CONSTRUCTION PLANS for KOINONIA RANCH

PCD PROJ. NO. **SF-21-035**

KOINONIA RANCH

CONSTRUCTION DRAWINGS

KOINONIA COURT
FROM STA 00+00.00
TO STA 15+00.00
KOINONIA RANCH
C1.2
SHEET 2 OF 3

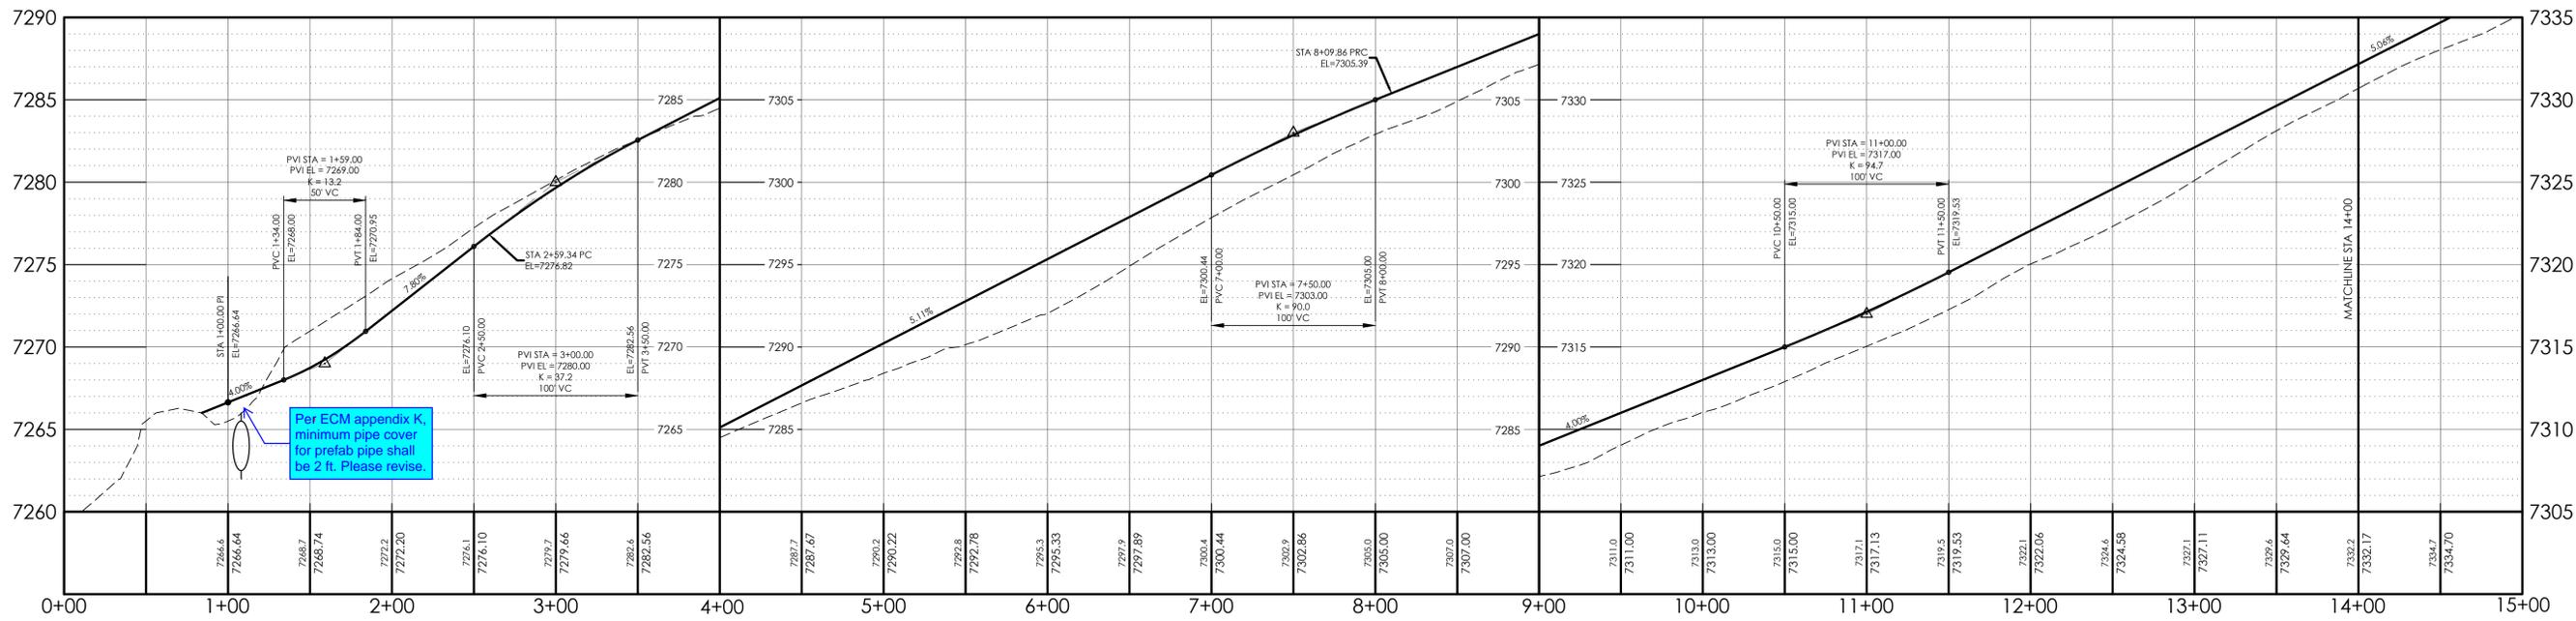
Please show ditch flowlines on profiles. Note that per ECM 2.5.8.C, ditches should have a minimum of 24 inch depth to accommodate driveway culverts.
